The Planning Inspectorate  
National Infrastructure Planning  
Temple Quay House  
2 The Square  
Bristol  
BS1 6PN

**Application by AQUIND Limited for an Order granting Development Consent for the AQUIND Interconnector Project (PINS reference: EN020022)  
Notification of Request to participate in Open Floor Hearing, Compulsory Acquisition Hearing, and Draft DCO Hearing on behalf of Mr. Geoffrey Carpenter and Mr Peter Carpenter (Registration Identification Number: 20025030)  
Submitted in relation to Deadline 1 of the Examination Timetable**

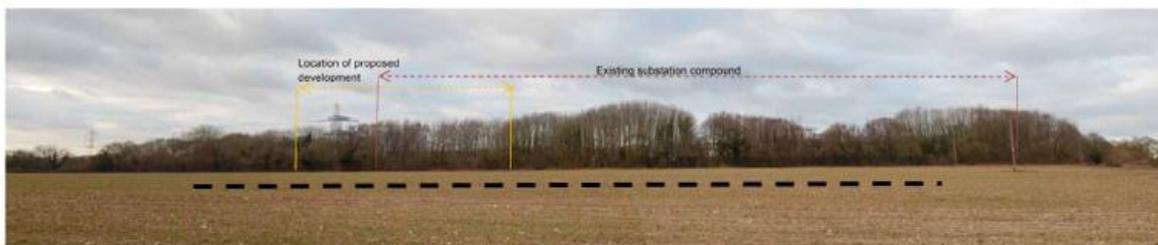
8. **Firstly**, the proposed native mixed woodland belt of up to 15m (Features Plan #7 above and Landscape Mitigation Plans APP-281 and APP-282) which is situated north of the proposed access road to the east of our Clients' land.

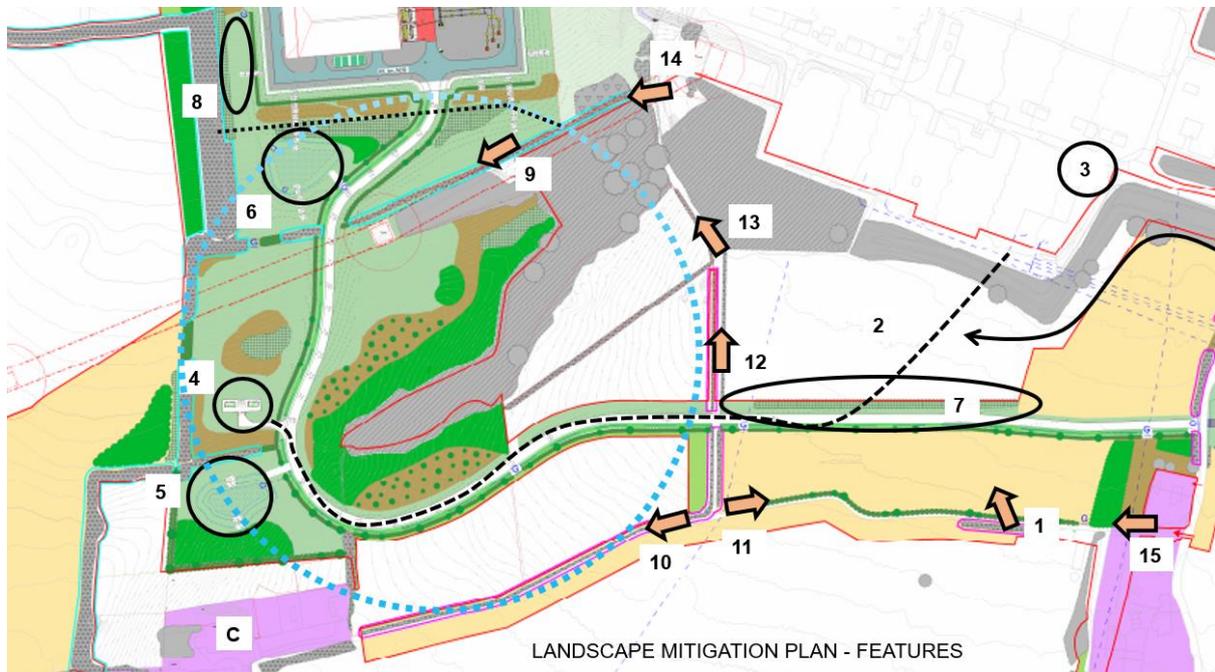
50. Given that the Converter Station is to be screened immediately adjacent to it, some of which is on new bunding created from the Station pad re-profiling works and the fact the Station may clad in sympathetic materials and colours (see indicative

photomontage from the Applicant's Environmental Statement (APP-268) Viewpoint A, see below), and that visual impression is ultimately subjective and beauty like benefit is in the eye of the beholder, the visual impression of the Station in a landscape dominated by existing pylons would likely be less visually intrusive than a lot of the existing agricultural buildings and the existing Substation, even on the Applicant's highest subjective position that it is "*minor-moderate significant adverse*".

51. Adequate visual landscaping of the Converter Station S can be secured by:
- Additional shrub planting near to the Converter Station (north of the black dotted line on the Features Plan) and positioned on any re-profiling to ensure maximum visual mitigation as soon as possible is achieved;

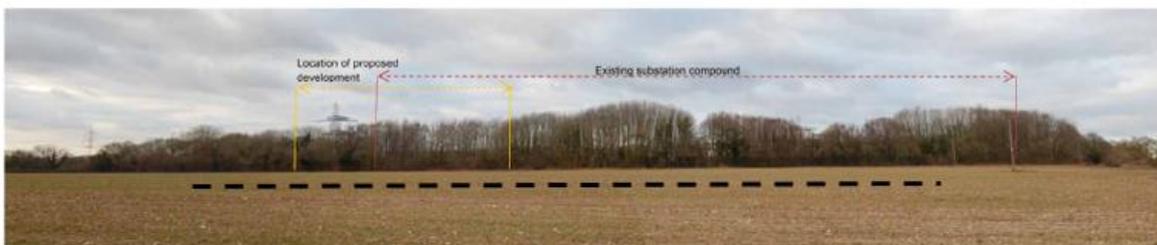
8. **Firstly**, the proposed native mixed woodland belt of up to 15m (Features Plan #7 above and Landscape Mitigation Plans APP-281 and APP-282) which is situated north of the proposed access road to the east of our Clients' land.

13. Indeed, below is an image of the maturity and density of Crabdens Row in the summer:

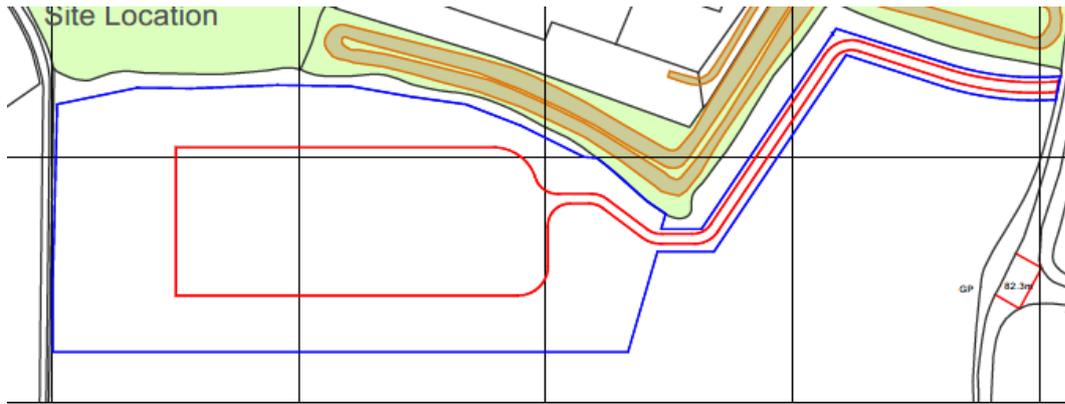
14. What this proposed planting strip (Features Plan #7 and shown black dashed line in the image above) would achieve, as a matter of fact, is no more than a screening of the northerly half of an existing agricultural field in the *short* highly localised view and a demarcation of the boundary of what would be a newly created smaller field. That is, a vegetated boundary would be created.
